CUSTOMER NOTIFICATION

| SUD-TT-0217-2-E |

**IE-789488-NS-EM1
(Control Code: E)**

Operating Precautions

Figure 3-1. Position of Emulation Board Fixing Stays (Metal Fittings)

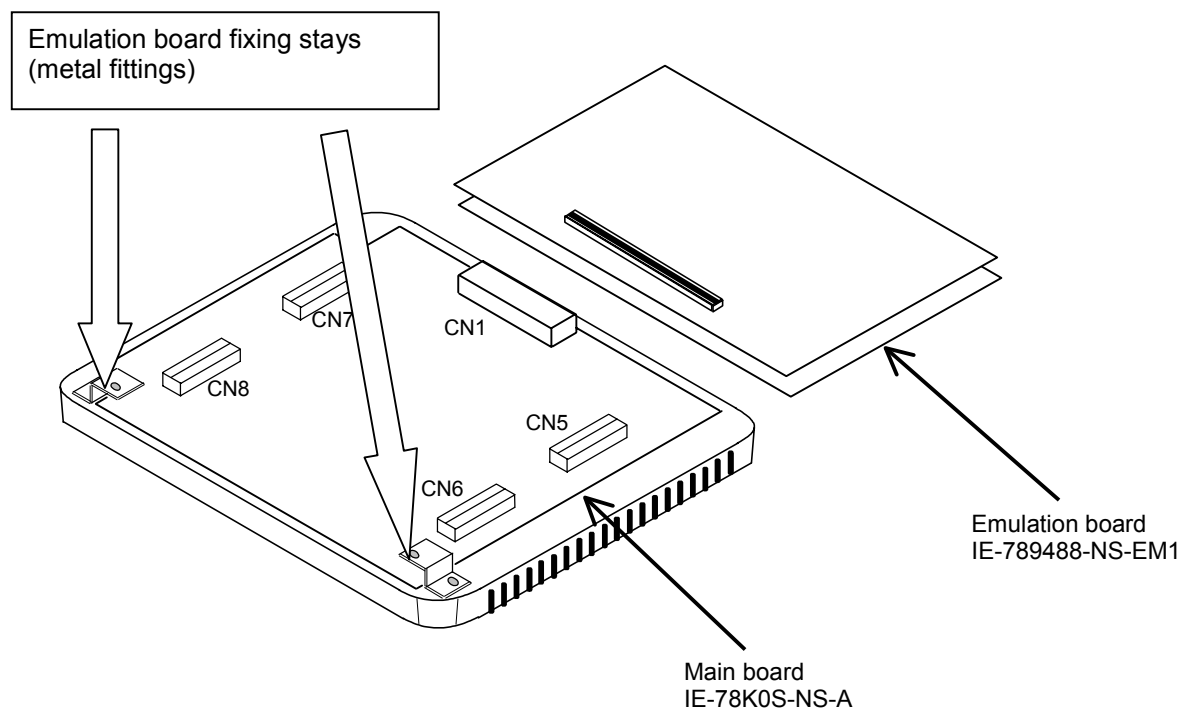
No.3 Contact bug between IE-78K0S-NS-A emulation board fixing stays (metal fittings) and test pins of the I/O board

When connecting the IE-789488-NS-EM1 to the IE-78K0S-NS-A control code A or B, test pins of the I/O board (CP8 and CP38) contact the IE-78K0S-NS-A emulation board fixing stays (metal fittings).

This bug has been corrected in control code C and later products.

Customers who have not yet upgraded to the IE-789488-NS-EM1 control code C should retain the IE-78K0-NS-A emulation board fixing stays (metal fittings). Figure 3-1 illustrates the position of the IE-78K0-NS-A emulation board fixing stays (metal fittings).

Be sure not to lose the removed emulation board fixing stays because these are used when upgrading the product.
